# **80C186EA/80C188EA AND 80L186EA/80L188EA EMBEDDED MICROPROCESSORS SPECIFICATION UPDATE**

Release Date: August, 1997

Order Number: 272896-003

**Figure 1. Correct INT1 Acknowledge Sequence with Higher Priority Timer Interrupt**

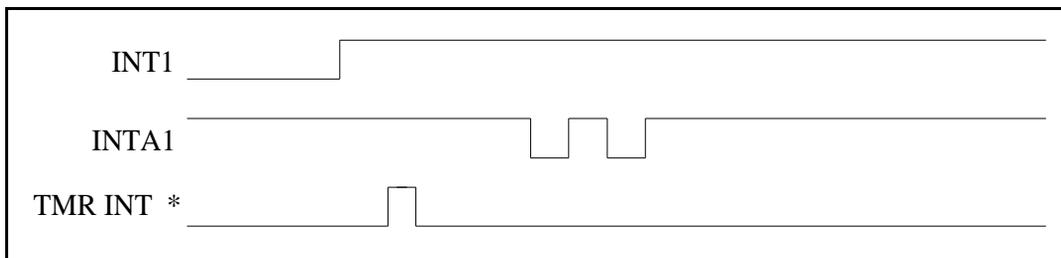
Correct operation of the device acknowledges the interrupt on INTA1# after an interrupt on INT1. Normally, this occurs even if there is a higher priority interrupt after INT1 but before the acknowledge (Figure 1).

**Figure 2. Incorrect INT1 Acknowledge Sequence with Higher Priority Timer Interrupt**

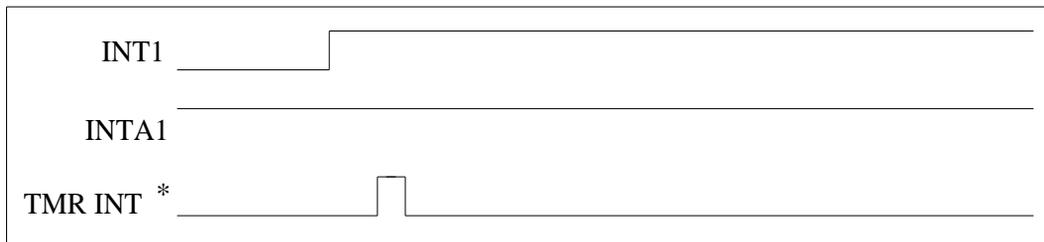
The errata occurs when a higher priority interrupt occurs between INT1 and its expected acknowledge. The processor completes internal interrupt acknowledge cycles as seen on the status lines but no acknowledge cycle is sent on the INTA1# output (Figure 2).

**Figure 3. INT0 And INT1 Acknowledge Failure due to Higher Priority Timer Interrupt**

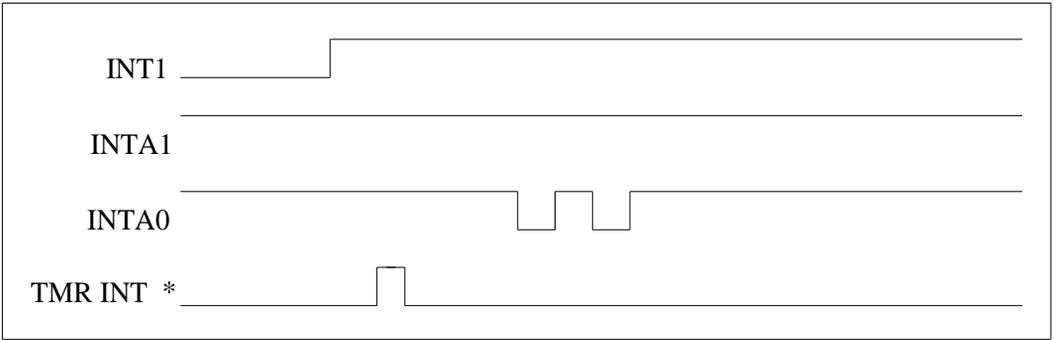
If INT0 and INT1 are configured in cascade mode and a higher priority interrupt occurs between INT1 and its expected acknowledge, then the acknowledge will appear on INTA0# instead (Figure 3).

**Figure 4. Correct INT0 Acknowledge Operation with a Simultaneous INT1**

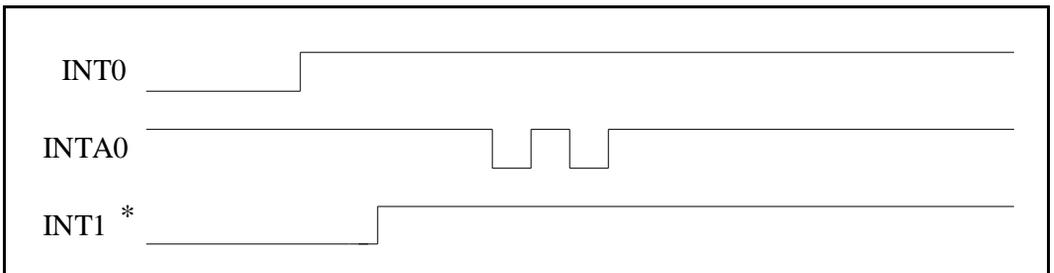
Correct operation acknowledges INT0 on INTA0#. Normally, this occurs even if there is a higher priority INT1 after INT0 but before the acknowledge (Figure 4).

**Figure 5. Incorrect INT0 Acknowledge Operation with a Simultaneous INT1**

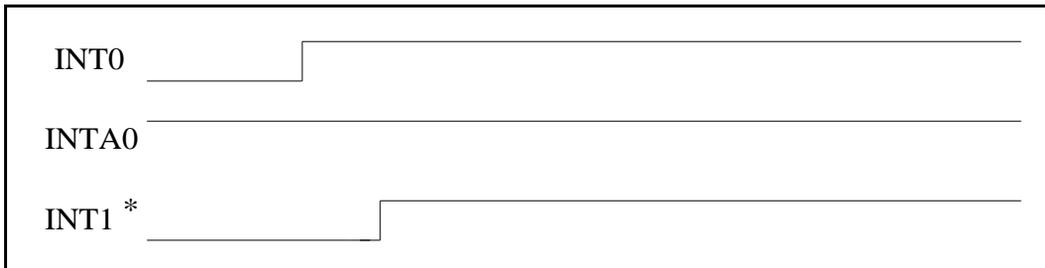
The errata occurs when INT1, which is higher priority than INT0, occurs between INT0 and its expected acknowledge. The processor completes internal interrupt acknowledge cycles as seen on the status lines but no acknowledge cycle is sent on the INTA0# output (Figure 5).

**Figure 6. INT0 and INT1 Acknowledge Failure Due to the Higher Priority INT1**

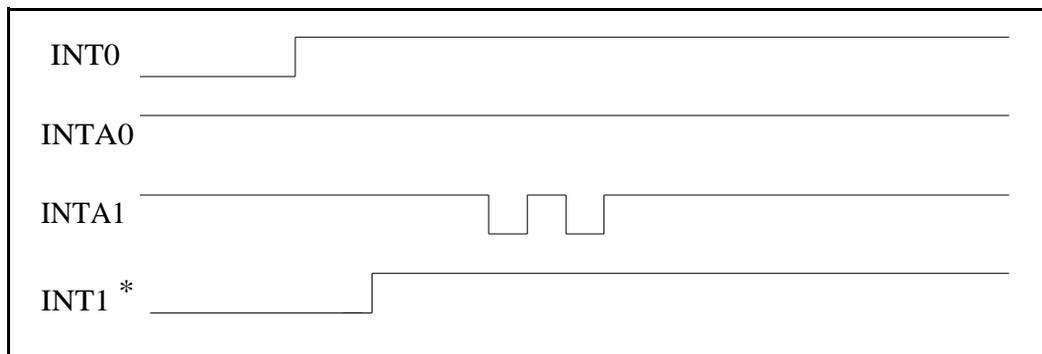
If INT0 and INT1 are configured in cascade mode and the higher priority INT1 occurs between INT0 and its expected acknowledge, then the acknowledge will appear on INTA1# instead of INTA0# (Figure 6).

Figure 7. NMI Ignored During HLT Entering Powerdown

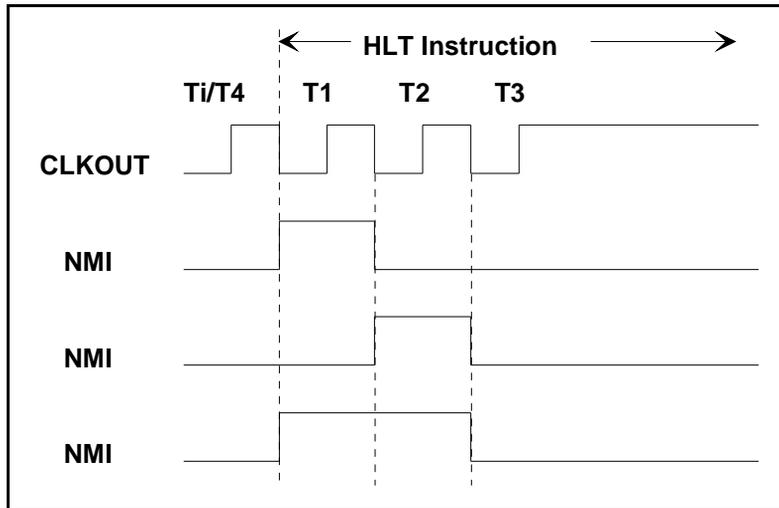
The problem occurs when an NMI occurs during execution of the HLT instruction. NMI is only serviced at valid instruction boundaries. The HLT instruction, when entering Powerdown, does not really have a boundary, it extends until Powerdown is exited. If NMI

occurs between the beginning the T1 bus state and the end of the T2 state, but does not extend into T3, it will not be recognized, and the processor will enter Powerdown mode. The processor does not recognize the NMI request during the HLT instruction until the internal clock has stopped (at the end of T2).

The figures below show NMI occurring at different times during execution of the HLT instruction. Two cases are shown. Figure 7 shows cases where NMI is not recognized. Figure 8 shows cases where NMI is recognized. Both cases assume setup and hold time requirements are met for the NMI input.

If the system requires periodic NMI pulses, then the NMI pulse width must be long enough to ensure that it will extend into the T3 state of the HLT instruction. A NMI pulse width of three CLKOUT periods guarantees this.

Figure 8. NMI Recognized During HLT Entering Powerdown

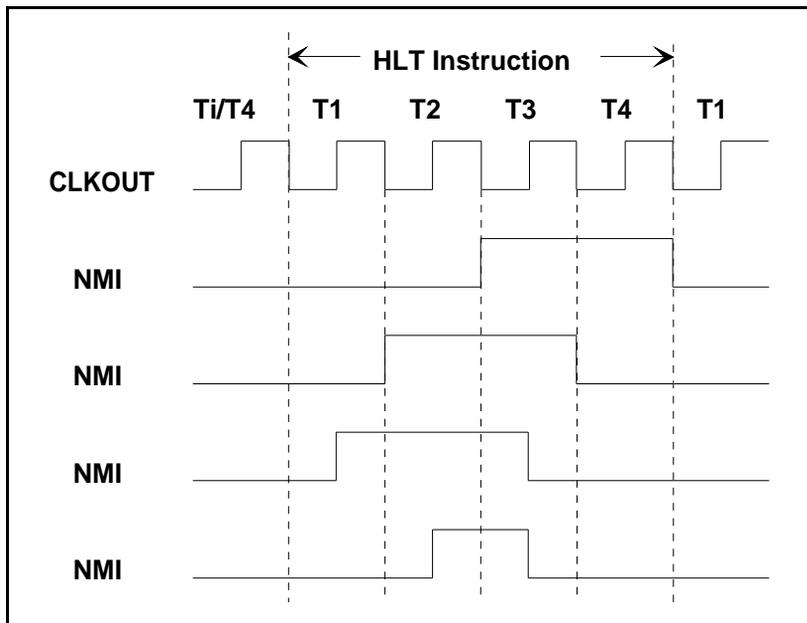
For the NMI to be recognized during the execution of the HLT instruction, the pulse must extend into T3. At this point, the processor has entered Powerdown and synchronized the NMI pulse. The NMI will be processed, but the processor will never enter Powerdown. Essentially, because NMI is active, the processor exits Powerdown as soon as it enters.
